## Public Comment for 1020 Hwy One Appeal AGENDA ITEM 2020-0374

## Comments To Be Made By Spokesperson Perry Marker, Property Owner, Full Time Resident and Registered Voter of 1030 Hwy One, Bodega Bay

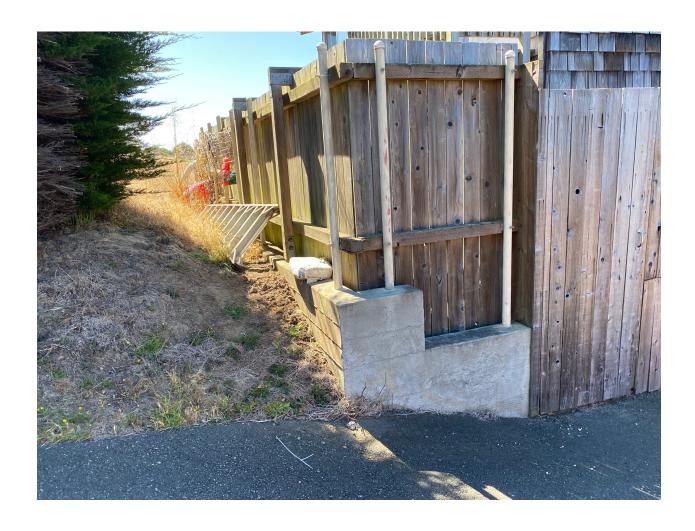
- There are significant safety concerns regarding the lot. The designed parking does not allow for a turnaround for trucks, delivery or emergency vehicles. Vehicles that cannot turn around **must back onto Hwy One** (see Photo #2\*) near a very hazardous blind curve. This creates a major safety issue on Hwy One. We request that the size of the

house be reduced, a parking turnaround be created for truck and emergency vehicles, to allow for an adquate turn around of vehicles
